A428 Black Cat to Caxton Gibbet improvements

TR010044

9.121 Applicant's response to the request for further information
from the Examining Authority – Rule 17 Letter

February 2022

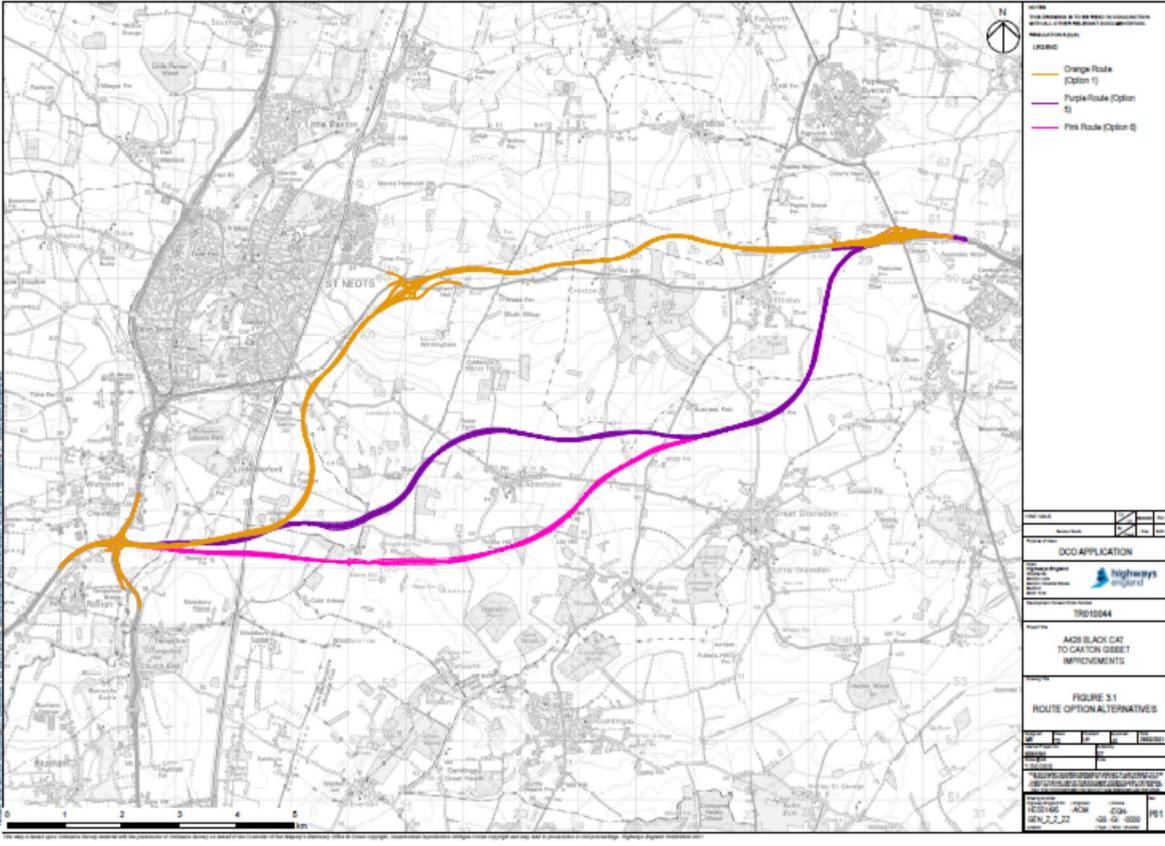
8.	<p>Flood Risk</p> <p>Applicant, in your response to the ExA's first written questions [REP1-022, Q1.9.1.1 a)], and your response [REP3-007] to the Environment Agency's (EA's) comments on your approach [REP1-076], you have not addressed the sequential approach taken to determine the route of the Proposed Development between the River Great Ouse and Caxton Gibbet roundabout, which sought to avoid areas at risk of flooding. This land is predominantly Flood Zone 1, but the preferred route crosses a number of ordinary watercourses at a higher risk of flooding, together with parts of their floodplains. Following a selection process three route options were considered at Non-Statutory Consultation, prior to the announcement of the preferred route [APP-035].</p> <p>Environment Agency, you have raised concerns with the Applicant's Flood Risk Assessment (FRA) during the Examination, including at [REP1-008] [REP1-076] [REP4-068] and [REP8-046]. The ExA notes that a version of the FRA Technical Note [REP6-042] will be shared with you by the Applicant, prior to the submission of a final version to the Examination at D10 [REP9-023, Q3.9.2.2].</p> <ol style="list-style-type: none"> Applicant, explain how the sequential approach to flood risk was used in determining the preferred route of the Proposed Development between the River Great Ouse and Caxton Gibbet roundabout. Environment Agency please provide comments. Applicant and Environment Agency, please ensure that any unresolved differences, with the FRA and FRA Technical Note, and their significance, are clearly set out in the final SOCG or in a supporting document to be submitted at D10.

Reference Number	Applicant's Comments
	<p>Consideration of the flood risk for alternative routes between the River Great Ouse and Caxton Gibbet Junction was considered during the Option Identification stage (PCF Stage 1). The Environment Agency was one of the stakeholders who attended the Environmental Forum during Stage 1 on 25 July 2016. The attendees were asked to identify specific environmental features that they felt should be considered in the process of Option Identification. Flood risk was one of the environmental issues and constraints raised and discussed at the forum. These issues and constraints were used to inform the qualitative assessment of 8 route options, including all feasible options between the River Great Ouse and Caxton Gibbet, which are offline. A summary of the options is in the Technical Appraisal Report and these reports are provided in Appendices G and I to the Overview of the Alternatives considered at the Black Cat Junction [REP4-033] respectively. The Technical Appraisal Report contains sections on Environmental Assessment and Assessment Summary at Chapters 18 and 19. In addition, Chapter 2.8 of the Stage 1 Environmental Assessment Report relates to the road drainage and the water environment and includes a section on flood risk and the Options Appraisal Matrix is reported at Appendix F.</p> <p>From this early stage, preference was given to locating the Scheme in areas least at risk of flooding, but it was evident that no viable route options that met the Scheme objectives could avoid crossing both the River Great Ouse and Hen Brook flood plains and meet the Scheme objectives. At this stage of Scheme development, all off line route options between the River Great Ouse and Caxton Gibbet were assessed to have a similar impact on the crossings of the River Great Ouse and Hen Brook, as well as several associated tributary flood plains. As a result, similar flood compensation measures would be required to mitigate the risk of major flood events for all of these route options. The environmental assessment of the route options is summarised in Table 19.2 of the Technical Appraisal Report. This assessment indicated that all the options between the River Great Ouse and Caxton Gibbet have the same “Red/Amber” adverse effect rating for Water Environment, except for Option 2 which was rated as “Amber”. However, as reported in Table 19.3 (Objective Summary Table) Option 2, an online upgrade proposal, was discounted on safety grounds and it also performed poorly against the “supporting economic growth” and “a more free flowing network” objectives.</p> <p>Three route options were taken forward from Stage 1 into Stage 2 and were presented at the Non-Statutory Consultation between the River Great Ouse and Caxton Gibbet. These were Option 1 (Orange), Option 5 (Purple) and Option 6 (Pink). A plan showing the route of these three options was shown in the Non-Statutory Consultation brochure [APP-035 Part B2] and in the Environmental Statement Figure 3.1 - Route Option Alternatives [APP-093]. A copy of Figure 3.1 showing the 3 main route options is presented below:</p>

Reference Number	Applicant's Comments
	 <p>The map displays three proposed route alternatives for the A428 Black Cat to Caxton Gibbet improvements. The routes are color-coded: Orange (Option 1), Purple (Option 2), and Pink (Option 3). The map shows the routes crossing the River Great Ouse flood plain and the Hen Brook and tributaries flood plain. A legend in the top right corner identifies the routes. The title block in the bottom right corner provides project details, including the DCO Application number (TR010044) and the project name (A428 BLACK CAT TO CAXTON GIBBET IMPROVEMENTS). The map also includes a north arrow and a scale bar.</p> <p>All three options involved one crossing of the River Great Ouse flood plain and one crossing of the Hen Brook and tributaries flood plain. The length of the flood plains impacted was similar for all three options. These options were designed to minimise the impact on the flood plains and other constraints. The next stage of flood risk assessment for the three options is provided in the Stage 2 Environmental Assessment Report at Appendix J to the Overview of the Alternatives considered at the Black Cat Junction [REP4-</p>
